Structural Calculations

Step By Step Greenhouse Expansion
2220149.20

Andrew McEachern, P.E., S.E.
Principal

March, 2022

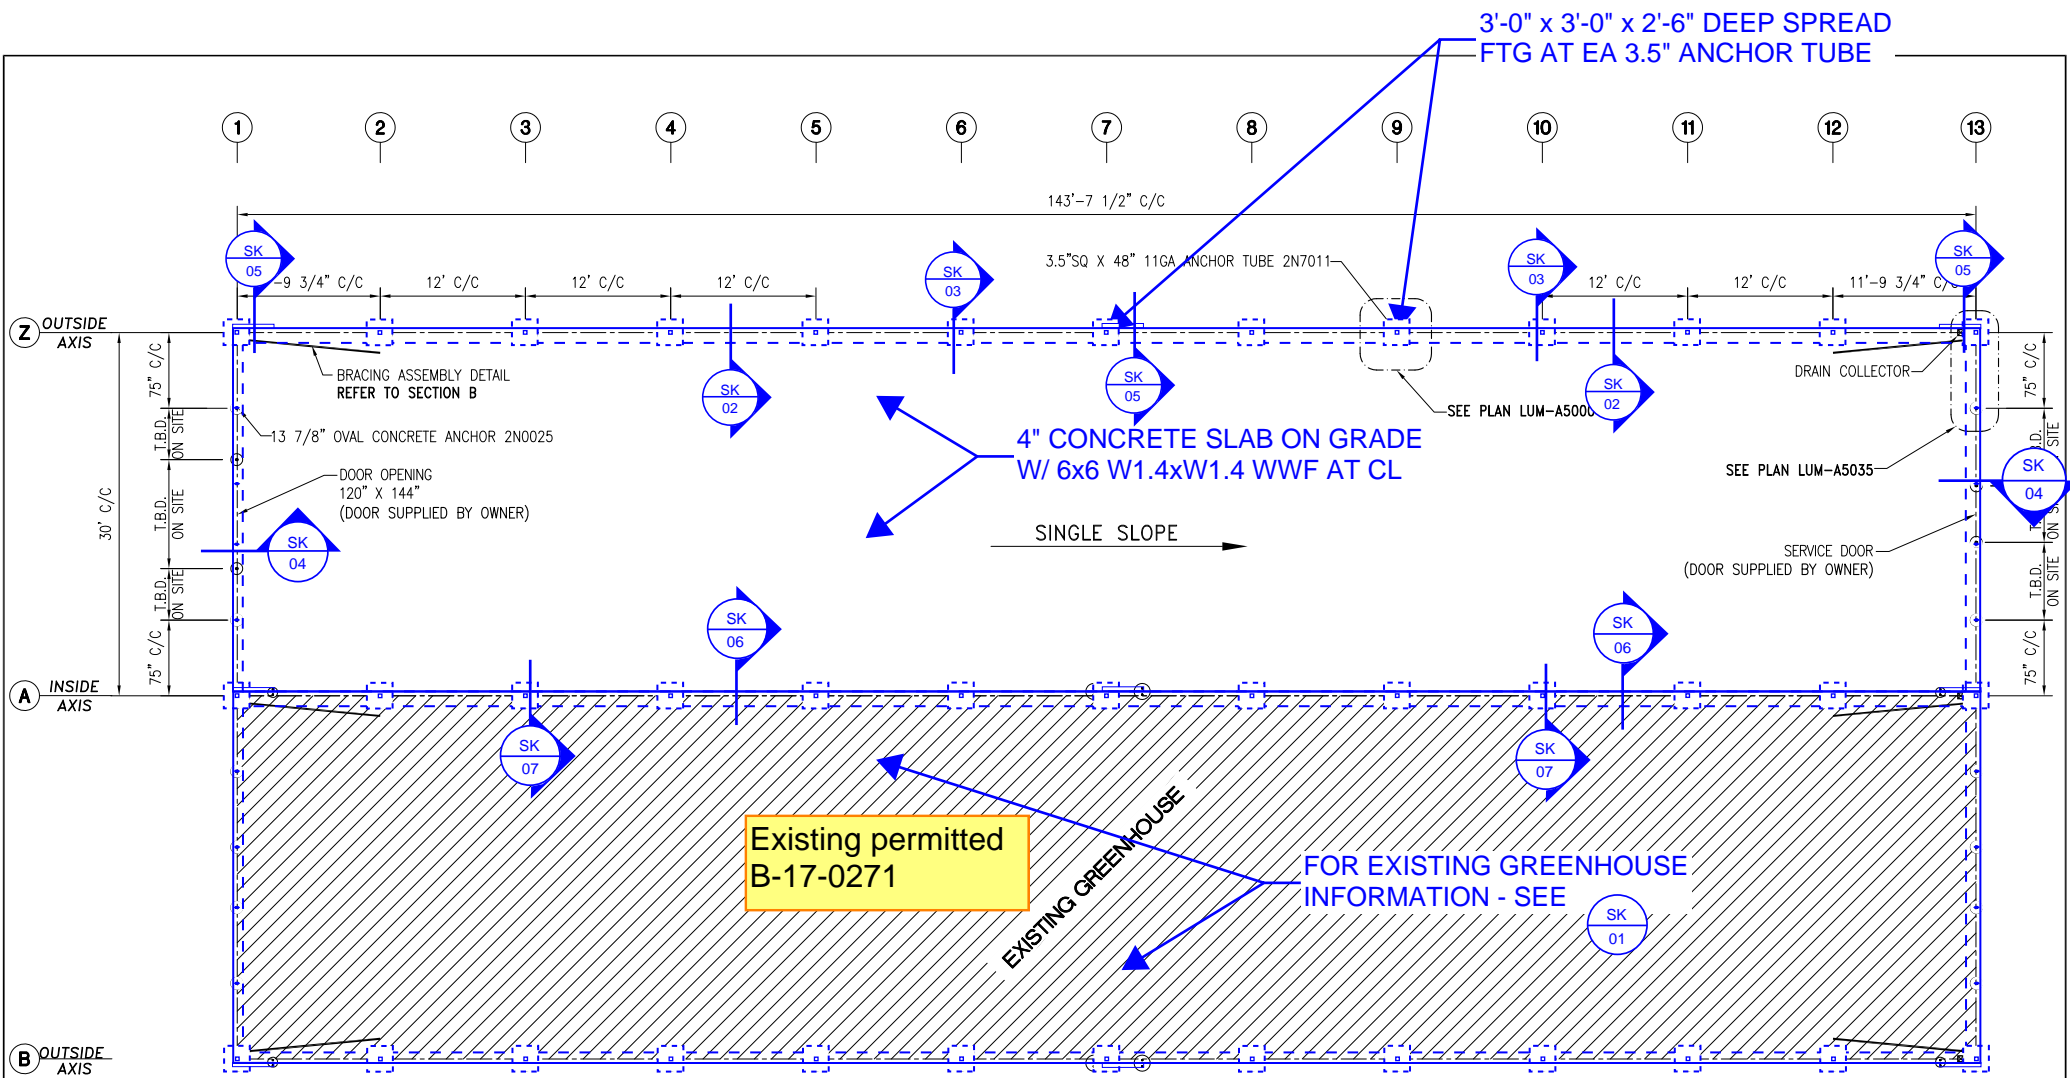
**SHEET 11/52:STRUCTURAL
NOTE DESIGN CRITERIA IS
STRUCTURALLY
ACCEPTABLE**

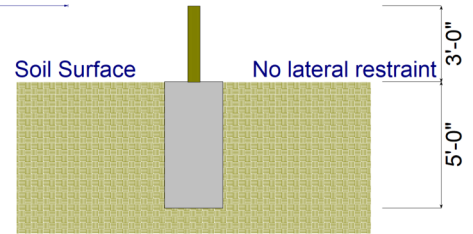
Sheet 47/52: Provide Calculations per current 2018 IBC adopted code for all calculations.
